INSERVICES INSPECTION

REV. 1-28-71
 BUILDING: AUX
 ZONE A-3
 ISO. NO.: MCFI - 2ND-15
 DUKE PIPING CLASS: B, ASME III
 SYSTEM SYMBOL: ND, RESIDUAL HEAT REMOVAL
 PIPING SPEC: ND 04.06 PS 601.2 EL. 733'-0"
 DRAWING NO.: MC 2414-04-93-01 REV. 3
 PROJECT: MCGUIRE

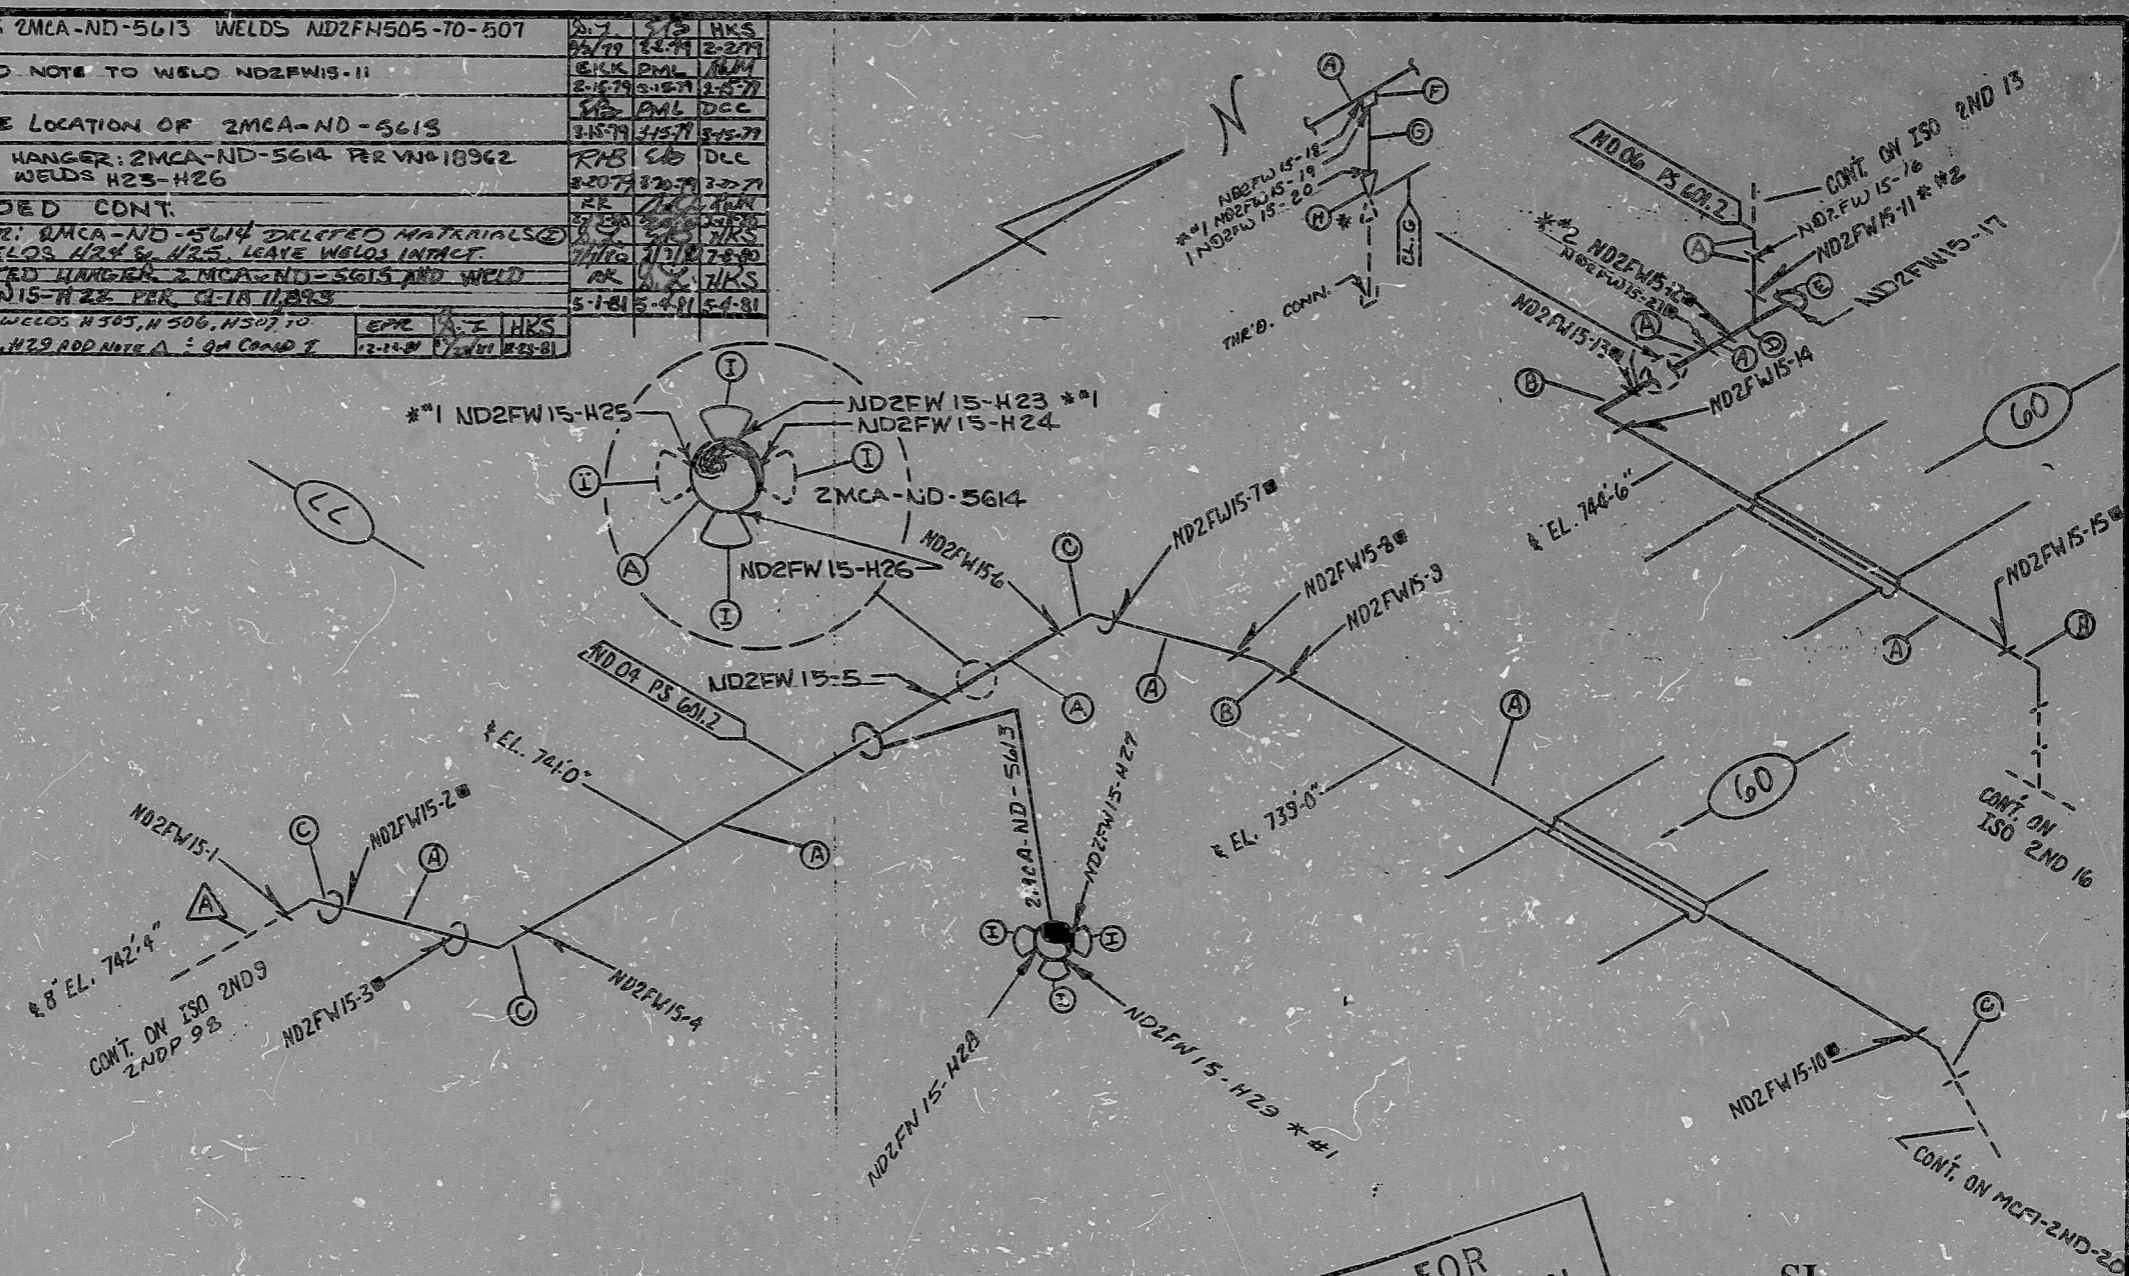
ADD NOTE *1 WELDS 18, 19, 20 AND MAT. "F", "G" AND "H" PER V.N. 18155
 UNIBZIG: ADDED MATERIAL @C & WELD ND2FW15-17
 ADD WELD ND2FW15-16
 ADDED RADIATION NOTE
 REL FOR CONSTR.
 REVISION O.A. CONDITION I

9	HANGER: 2MCA-ND-5613 WELDS ND2FW1505-70-507	WRS	WRS	HKS
10	ADDED NOTE TO WELD ND2FW15-11	WRS	WRS	HKS
11	CHANGE LOCATION OF 2MCA-ND-5613	WRS	WRS	HKS
12	ADDED HANGER: 2MCA-ND-5614 PER V.N. 18962 ADDED WELDS H25-H26	WRS	WRS	HKS
13	ADDED CONT.	WRS	WRS	HKS
14	HANGER: 2MCA-ND-5614 DELETED MATERIALS AT WELDS H25 & H26. LEAVE WELDS INTACT	WRS	WRS	HKS
15	DELETED HANGER: 2MCA-ND-5613 AND WELD ND2FW15-H28 PER 04-18-11093	WRS	WRS	HKS
16	CHANGE WELDS H 505, H 506, H 507 TO H 27, H 28, H 29 ADD NOTE A: QA COND 7	WRS	WRS	HKS

6	ADD WELD ND2FW15-81 BETWEEN WELDS 12 + 13 PER FIELD	WRS	WRS	HKS
5	CHANGE SCH. OF TEE & CAP (V.N. 10349) FROM SCH 20 TO 40 AND ADD NOTE *2	WRS	WRS	HKS

8	ADDED HANGER 2MCA-ND-5615, AND WELD ND2FW15-22	WRS	WRS	HKS
7	FAB SHOP NOTE	WRS	WRS	HKS
